TO: The Honorable Members of City Council

FR: Property Owners in the area of 816 Ormond Street (Authored by David Topian)

RE: Proposed Development project located:

City Petition #25-45SP

EXHIBIT 2
(1/8" = 1'-0")

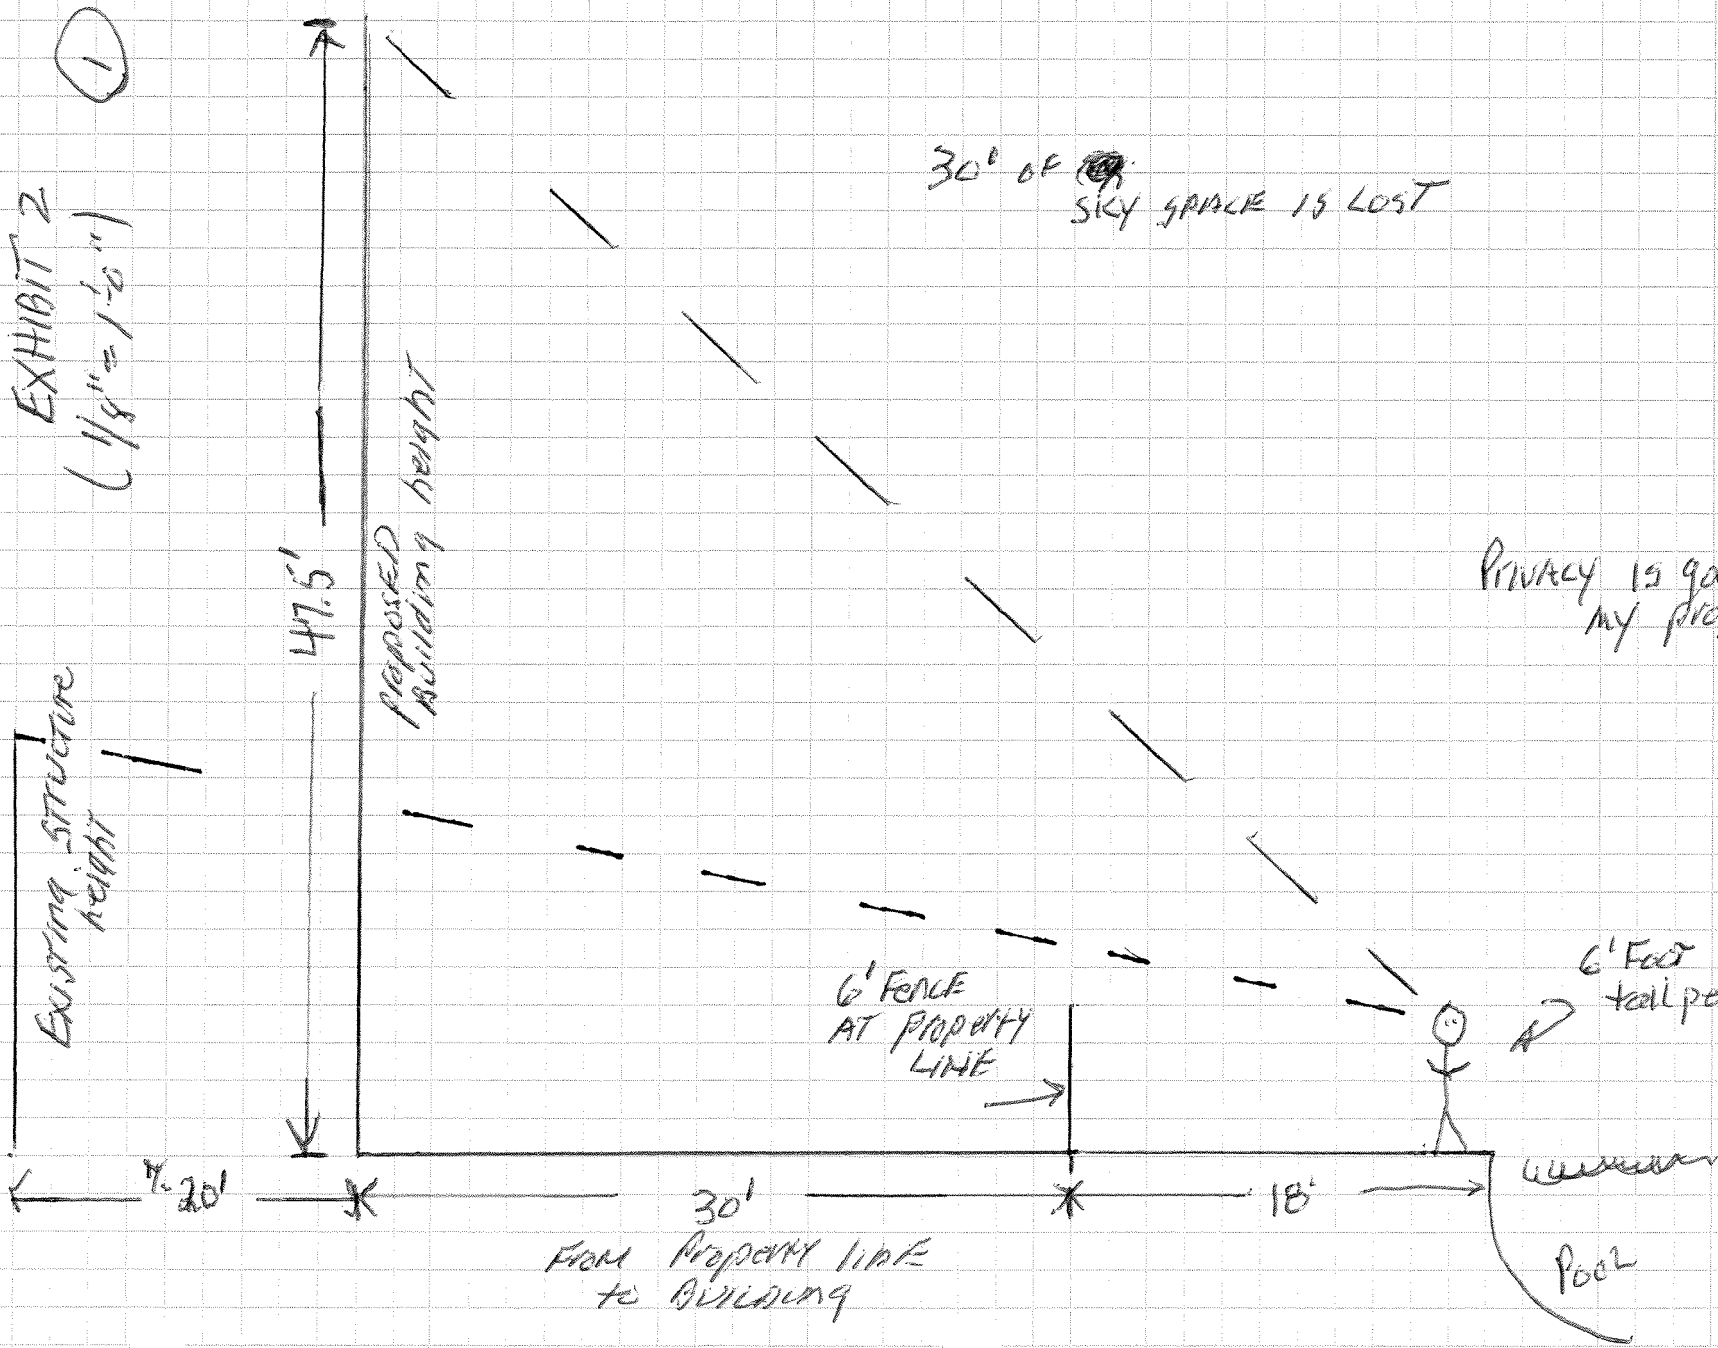
1. **Height.** The current proposed height of this six-unit structure has a roof height of 47.5 feet (Coastal Architecture drawing A2.00 date 11/24). Building heights on Ormond and Madrid have a maximum height of 30’ (1 structure) with many below 20’ but an average of 21 feet. This proposed building clearly dwarfs all surrounding structures inclusive of all properties on Madrid, Heigl, Ormond and Apalachicola. We as neighbors (**Exhibit #4 Petition**) feel this is unjustified and unacceptable in height based upon surrounding existing homes. Lowering the building “compatible” with the neighborhood still allows 6 units but respects other neighbors and respects privacy. **We look to the Council for this amendment to documents.**

7. **Lighting.** Light pollution is a major factor in a building with this proposed mass. A lighting plan has not been provided to date however it appears by the elevation drawings A2.00 there are second and third floor balconies that look into Madrid Avenue residences backyard areas, it is assume these balconies will have a lights associated with them and/or additional strings of light set in place later by new unit owners shedding additional light on neighboring residences. **We look to the Council to protect existing neighboring properties.**

Privacy is gone on
my property

30° of sky space is lost
